MAINTENANCE INFORMATION

MI16-22

DATE: APRIL 2016 SECTION: 06 - Electrical
SUBJECT: MARKER LIGHTS ON IN SLEEP MODE

X3SERIES US07 VOLVO D13 ENGINE

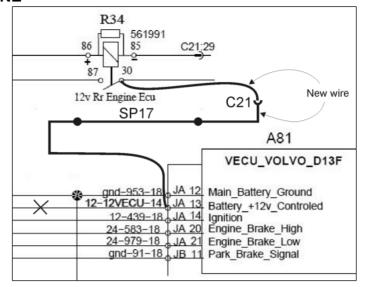
- In rear electrical compartment, locate relay R34
- 2. Remove existing tab terminal at pin 30.
- 3. Crimp a new wire #562593 and existing 12ECU wire on #562368 tab terminal. Replace at pin 30 of R34.
- 4. Install #563588 pin and #563603 socket terminal to pass through connector C21. (Use extractor tool #682321 as required)
- Connect new wire end with SP17.
 #562228 butt splice
 #560784 shrink tube
- 6. In front electrical and service compartment, cut wire 12VECU at VECU JA13 in front junction box.
- 7. Run a new 12VECU wire from SP17 to JA13. Install #562771 terminal and connect.
- 8. Once completed, remove R22 Relay from VECF as it is now unused.
